APPLICATION FOR BYPRODUCT MATERIAL LICENSE INDUSTRIAL

DOWNEAST PEAT L.P. POWER PLANT

PLEASE FIND ATTACHED OUR ANSWERS
TO YOUR FAX CONCERNING LEVEL
DETECTORS BY OHMART. (DU-1)

"LEVELART" - LEVEL GAUGES

MS 1901

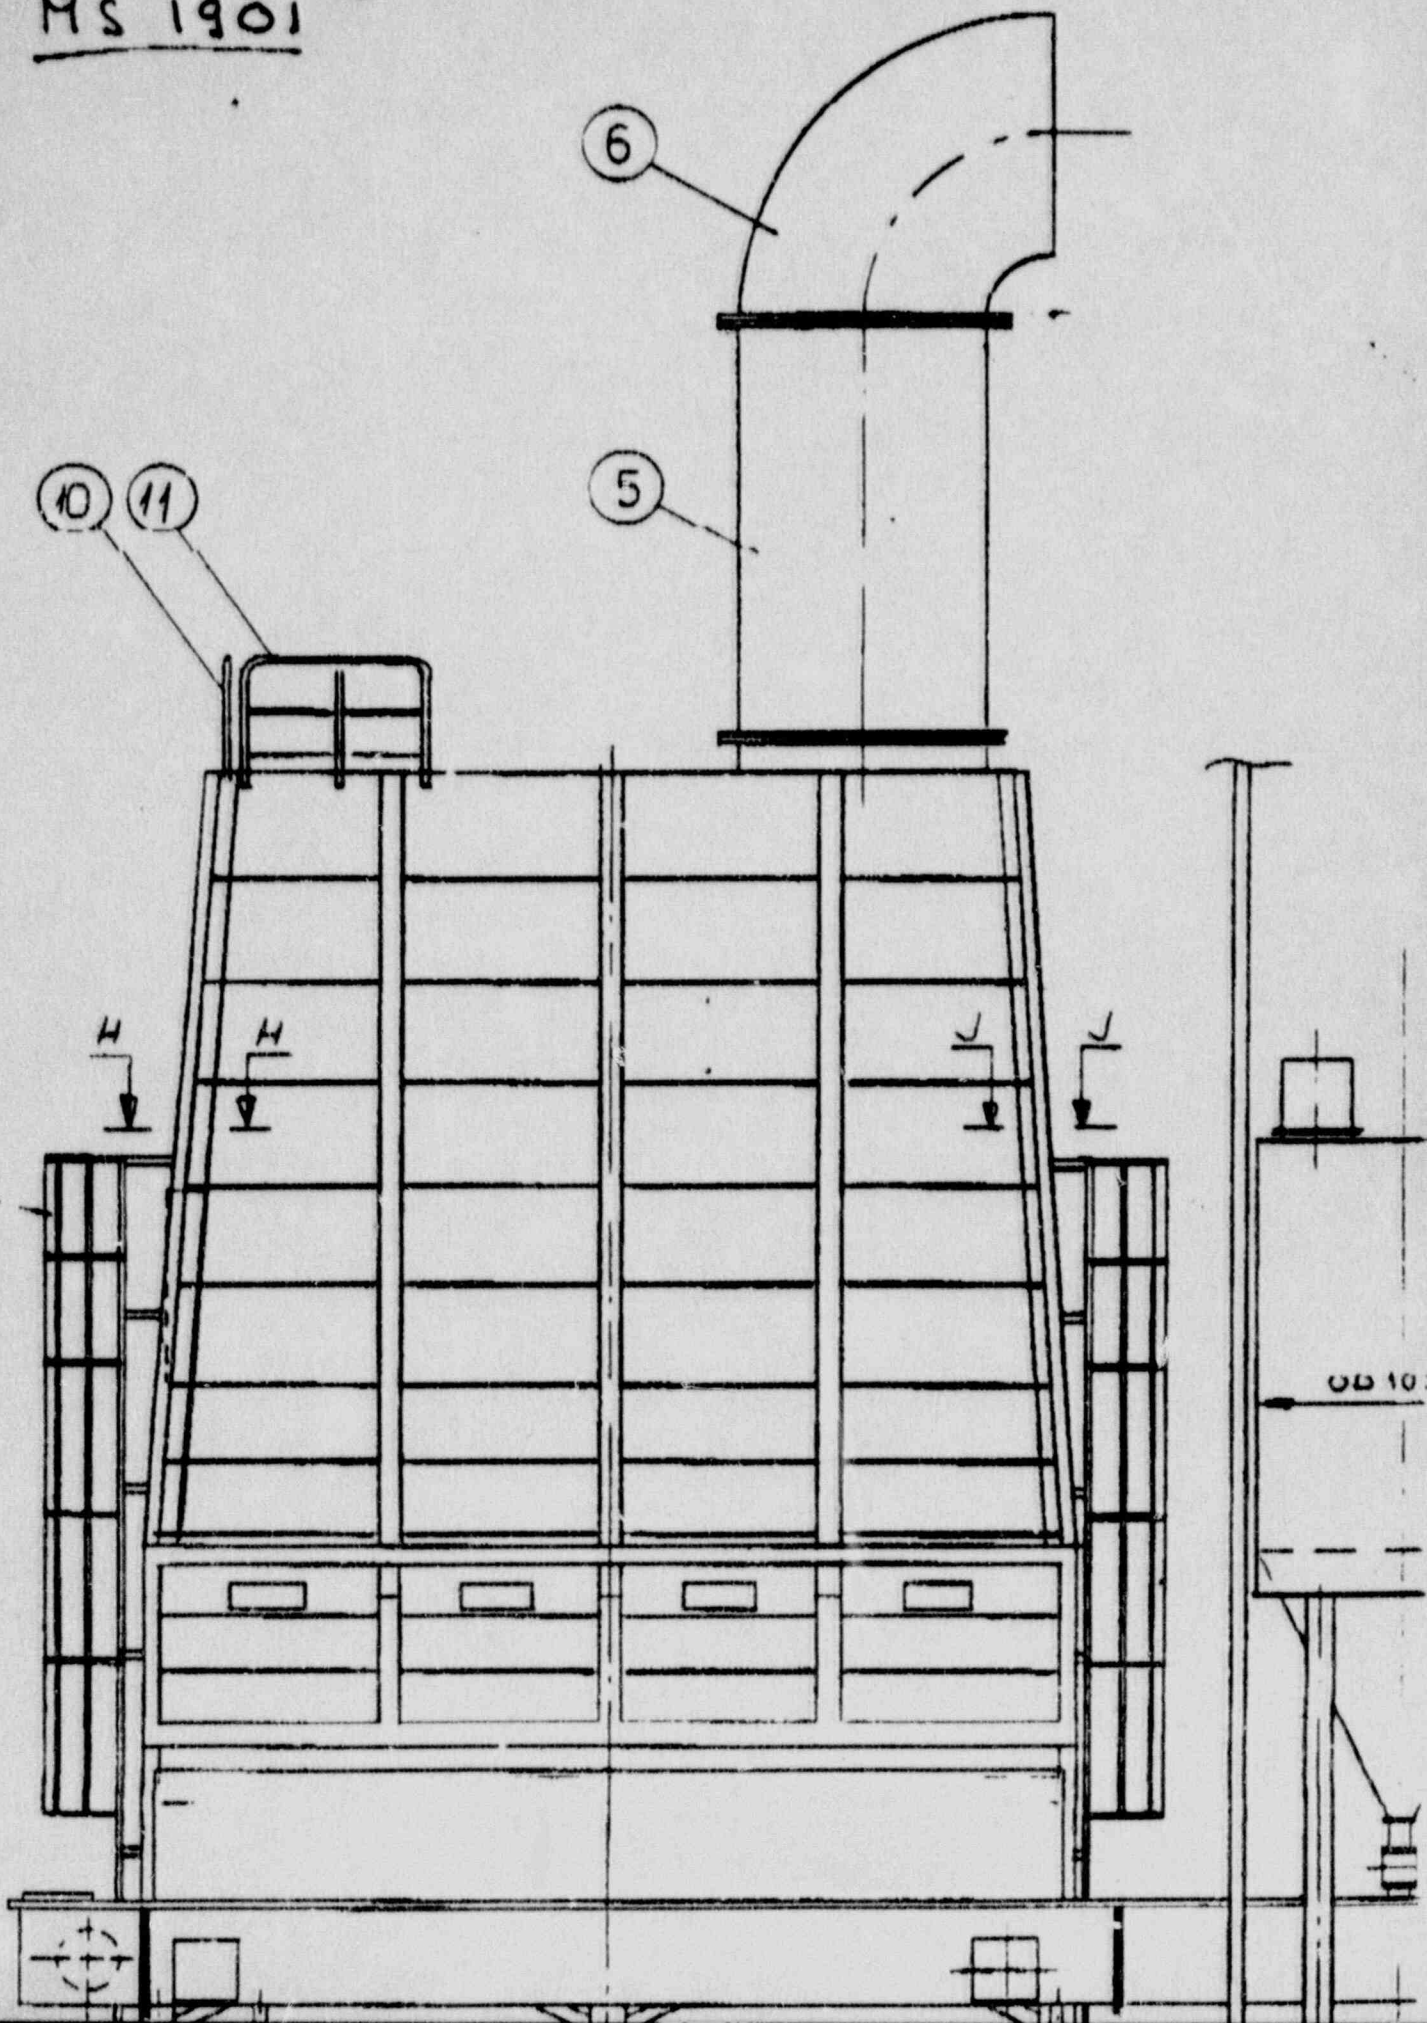
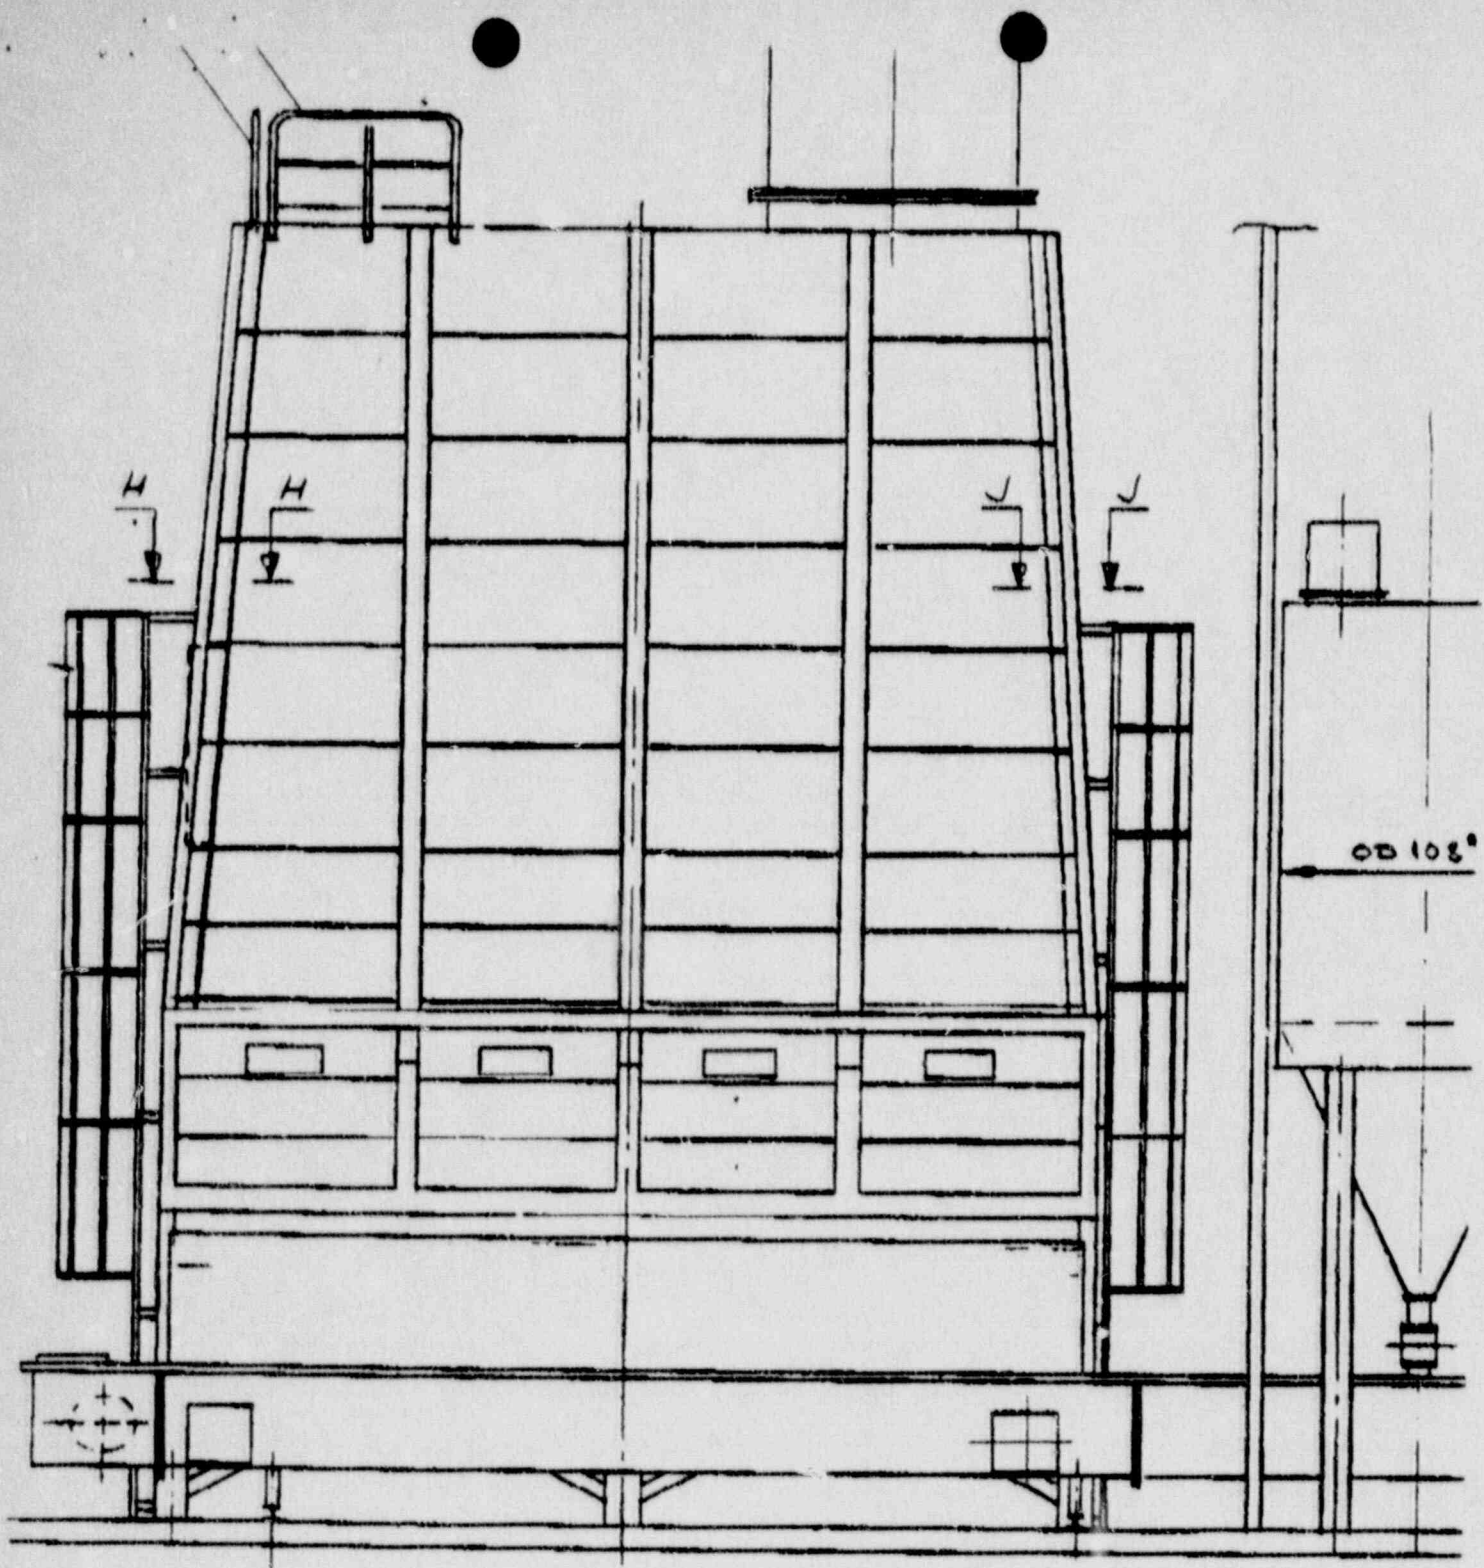
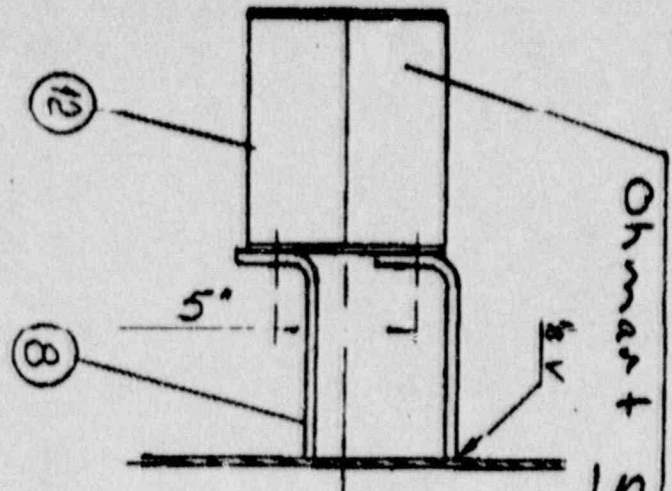
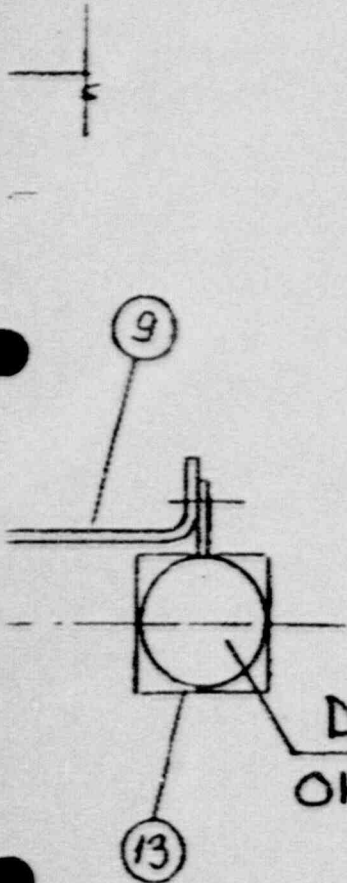
- 1 The detectors are attached to the peat storage silos (3), chain conveyor hoppers (3) and unloading chute of belt conveyor. The silos and hoppers are in the boiler house building and the chute is outside. The connections are shown in the attached sketches.
- 2 The temperature inside the building may vary from 0 to 30 centigrade. The atmosphere is slightly corrosive.
- 3 The ambient temperature in the spaces, where the detectors are located, does not exceed the temperature limits (-40 to +70 degrees centigrade) set for the detectors.
- 4 N/A
